Re: AES Indiana's 2022 Integrated Resource Plan

# Report on AES Indiana's 2022 Integrated Resource Plan

Submitted to the IURC on March 31, 2023

Figure 1. Base, Low, High Peak Demand Forecasts

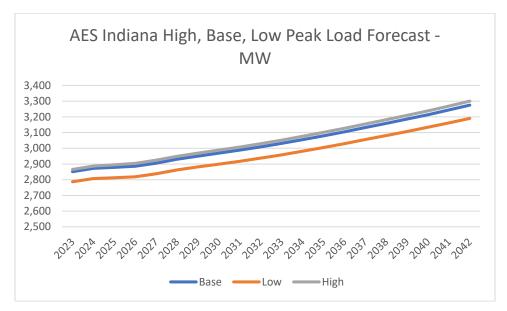
As Figure 1 displays further, there is little difference between the Company's base and high peak demand forecasts. This suggests either the Company's base forecast is too high, or the Company's high forecast provides little additional value to the IRP and Stakeholders.
